NEW ELEMENTARY SCHOOL
9801 HIGHLAND KNOLLS DR
BAKERSFIELD CALIFORNIA 93306

NEW MIDDLE SCHOOL
4115 VINELAND ROAD
BAKERSFIELD CALIFORNIA 93306

ORDIZ-MELBY ARCHITECTS, INC. 2010
SHEET TITLE
ELECTRICAL SITE PLAN

SHEET IDENTIFICATION NUMBER
E-111
SHEET OF

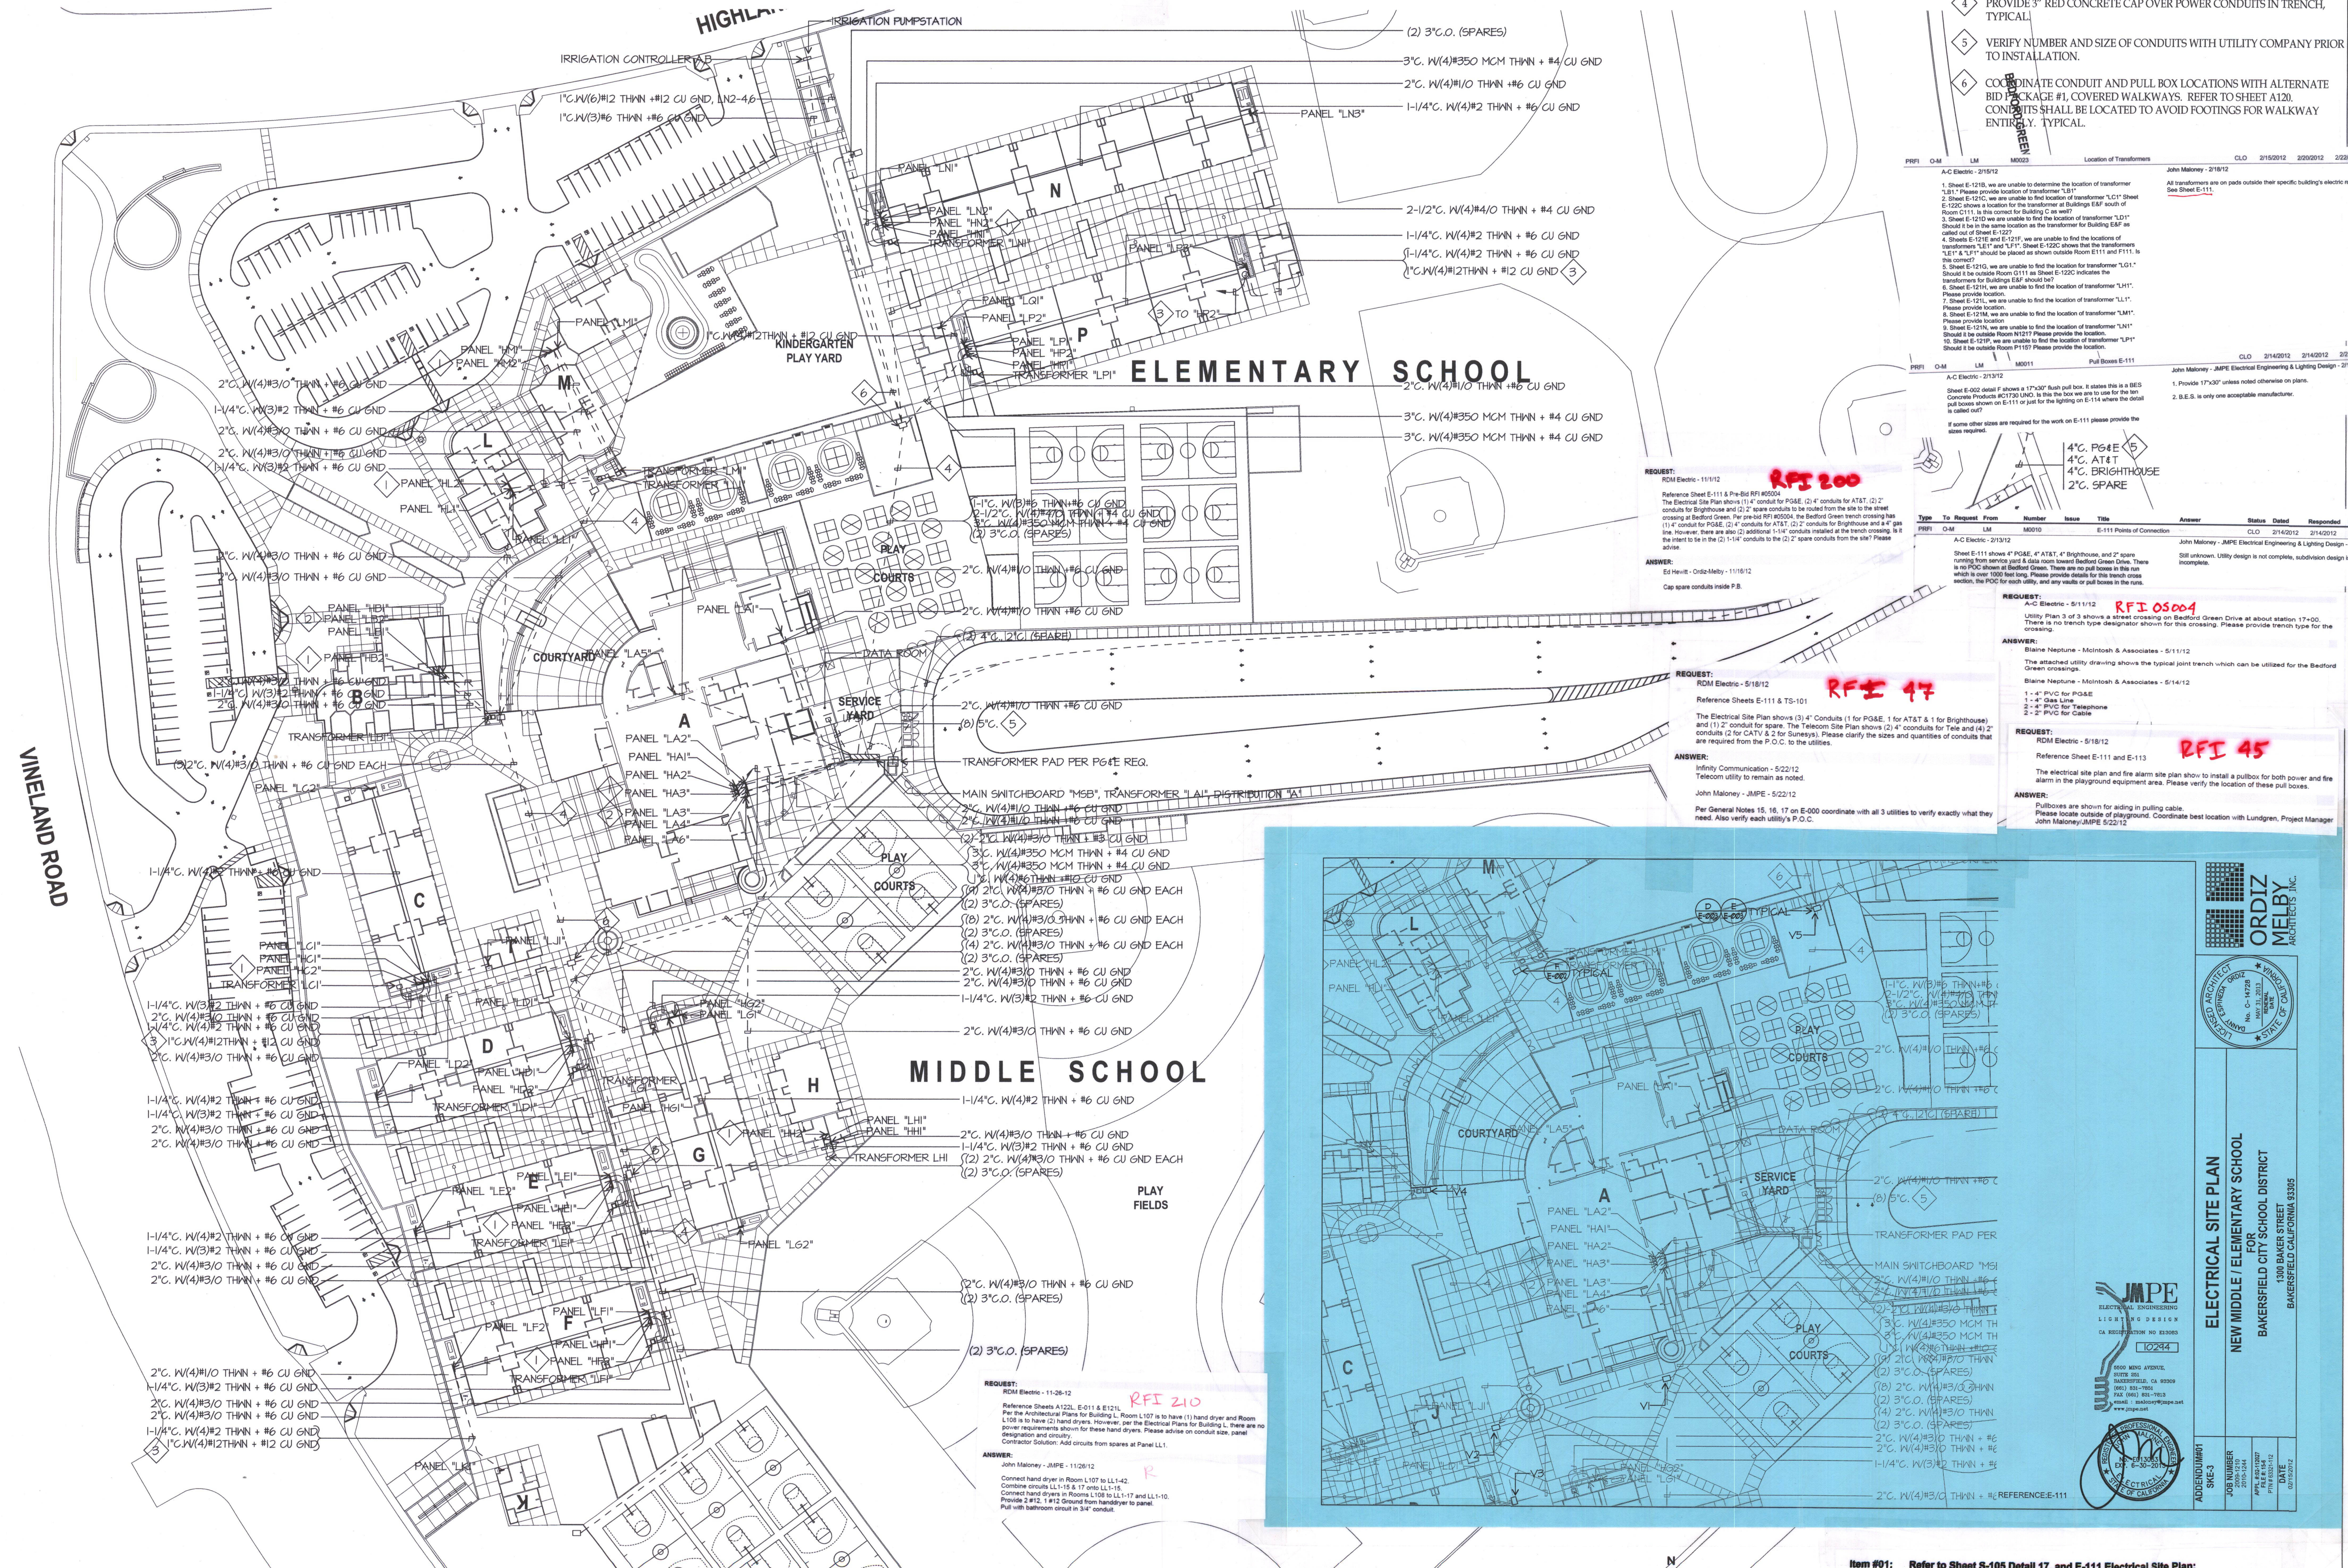
REQUEST:
RDM Electric - 11/1/12
Reference Sheet E-111 & P-801 RFI 200R
The Electrical Site Plan shows (1) 4" conduit for PG&E, (2) 4" conduits for AT&T, (2) 2" conduits for BrightHouse and (2) 2" spare conduits to be routed from the site to the street crossing at Bedford Green. For conduit RFI 200R, the Bedford Green trench crossing has 11" 4" conduit for PG&E, (2) 4" conduits for AT&T, (2) 2" conduits for BrightHouse and 4" 2" spare conduits to be routed from the site to the street crossing. Please advise.

REQUEST:
RDM Electric - 3/20/13
Reference Sheets E-111, E-113 & E-114 RFI 285
1. Please confirm per the approved submittal that for the alarm and photovoltaic pullboxes it is acceptable to install the Brooks Products #209B 12" x 22" concrete pullbox with a Brooks Products #209 GALVANIZED steel, diamond plate, foot down cover.
2. Please confirm per the approved submittal that for the site lighting, pole, signal and CATV it is acceptable to install the Brooks Products #209B 17" x 20" concrete pullbox with a Brooks Products #209B GALVANIZED steel, diamond plate, foot down cover.
PLEASE NOTE THAT THIS RFI IS VERY TIME SENSITIVE AS THE PLATWORK CONCRETE POUR HAS ALREADY BEGUN.

REQUEST:
RDM Electric - 11/1/12
Reference Sheet E-111 & P-801 RFI 200
The Electrical Site Plan shows (1) 4" conduit for PG&E, (2) 4" conduits for AT&T, (2) 2" conduits for BrightHouse and (2) 2" spare conduits to be routed from the site to the street crossing at Bedford Green. For conduit RFI 200R, the Bedford Green trench crossing has 11" 4" conduit for PG&E, (2) 4" conduits for AT&T, (2) 2" conduits for BrightHouse and 4" 2" spare conduits to be routed from the site to the street crossing. Please advise.

REQUEST:
RDM Electric - 5/18/12
Reference Sheets E-111 & TS-101
The Electrical Site Plan shows (3) 4" Conduits (1 for PG&E, 1 for AT&T & 1 for BrightHouse) and (1) 2" conduit for spare. The Telecom Site Plan shows (2) 4" conduits for Tele and (4) 2" conduits (2 for CATV & 2 for Sunways). Please clarify the sizes and quantities of conduits that are required from the P.O.C. to the utilities.

PRJ#	Q#	LM	M003	Location of Transformer	John Maloney - 2/18/12	All transformers are on pads outside their specific building's electric room. See Sheet E-111.
A-C Electric - 2/15/12	1	Sheet E-121B, we are unable to determine the location of transformer "L21". Please provide location of transformer "L21".	2	Sheet E-121C, we are unable to find location of transformer "L21". Sheet E-122C shows a location for transformer at Building EAF south of Room C111. Is this correct for Building C as well?	3	Sheet E-121D we are unable to find the location of transformer "L21". Should it be in the same location as the transformer for Building EAF as called out in Sheet E-122C? we are unable to find the location of transformer "L21" and "L21". Sheet E-122C shows that the transformer "L21" should be located in Room E111 and P111 in the corner?

PRJ#	Q#	LM	M011	Pull Boxes E-111	John Maloney - JMPE Electrical Engineering & Lighting Design - 2/14/12	1. Provide 17x30" unless noted otherwise on plans. 2. B.E.S. is only one acceptable manufacturer.
A-C Electric - 2/15/12	1	Sheet E-000 detail # shows a 17x30" pull box. It states this is a B.E.S. Concrete Products #C70 (N9). Is this the box we are to use for the top pull boxes shown on E-111 or just for the lighting on E-111 where the detail is called out?	2	Sheet E-111 shows 4" PG&E, 4" AT&T, 4" BrightHouse, and 2" spare running from across street & data room toward Bedford Green. There is no P.O.C. shown at Bedford Green. There are no pull boxes in the run which is over 100' long. Please provide details for the trench crossing, the P.O.C. for each utility, and any results of pull boxes in the run.

PRJ#	Q#	LM	M012	E-111 Points of Connection	John Maloney - JMPE Electrical Engineering & Lighting Design - 2/14/12	1. Provide 17x30" unless noted otherwise on plans. 2. B.E.S. is only one acceptable manufacturer.
A-C Electric - 2/15/12	1	Sheet E-111 shows 4" PG&E, 4" AT&T, 4" BrightHouse, and 2" spare running from across street & data room toward Bedford Green. There is no P.O.C. shown at Bedford Green. There are no pull boxes in the run which is over 100' long. Please provide details for the trench crossing, the P.O.C. for each utility, and any results of pull boxes in the run.

PRJ#	Q#	LM	M013	Utility Plan 3 of 3 shows a street crossing on Bedford Green Drive at about station 17+00. There is no trench type designator shown for this crossing. Please provide trench type for the crossing.	Blaine Neptune - McInosh & Associates - 5/14/12	1 - 4" PVC for PG&E 1 - 4" Gal Line 2 - 2" PVC for Telephone 2 - 2" PVC for Cable
A-C Electric - 5/11/12	1	Utility Plan 3 of 3 shows a street crossing on Bedford Green Drive at about station 17+00. There is no trench type designator shown for this crossing. Please provide trench type for the crossing.

PRJ#	Q#	LM	M014	Blaine Neptune - McInosh & Associates - 5/14/12	RDM Electric - 5/18/12	Reference Sheet E-111 and E-113 The electrical site plan and fire alarm site plan show to install a pullbox for both power and fire alarm in the playground equipment area. Please verify the location of these pull boxes.
A-C Electric - 5/11/12	1	Blaine Neptune - McInosh & Associates - 5/14/12

Item #01: Refer to Sheet S-105 Detail 17, and E-111 Electrical Site Plan:
A. CLARIFY: Position of Concrete Masonry footing shall be adjusted to accommodate location of required conduits for Main Switchboard unit per Drawings ASI-26.1, ASI-26.2, and ASI-26.3 as attached.

ANSWER:
John Maloney - JMPE - 11/28/12
1. This is acceptable.
2. Site lighting does not require 17x30" pull boxes at each light pole. Provide N9 pull boxes at poles.
3. Brooks is an approved manufacturer. Pull box type with lids described above are acceptable. If site routing is changed from plans, larger size pull boxes may be required.

ANSWER:
John Maloney - JMPE - 3/20/13
1. This is acceptable.
2. Site lighting does not require 17x30" pull boxes at each light pole. Provide N9 pull boxes at poles.
3. Brooks is an approved manufacturer. Pull box type with lids described above are acceptable. If site routing is changed from plans, larger size pull boxes may be required.

ANSWER:
Ed Hevitt - Ordiz-Melby - 11/16/12
Cap spare conduits inside P.B.

ANSWER:
Infinity Communication - 5/22/12
Telecom utility to remain as noted.
John Maloney - JMPE - 5/22/12
Per General Notes 15, 16, 17 on E-000 coordinate with all 3 utilities to verify exactly what they need. Also verify each utility's P.O.C.
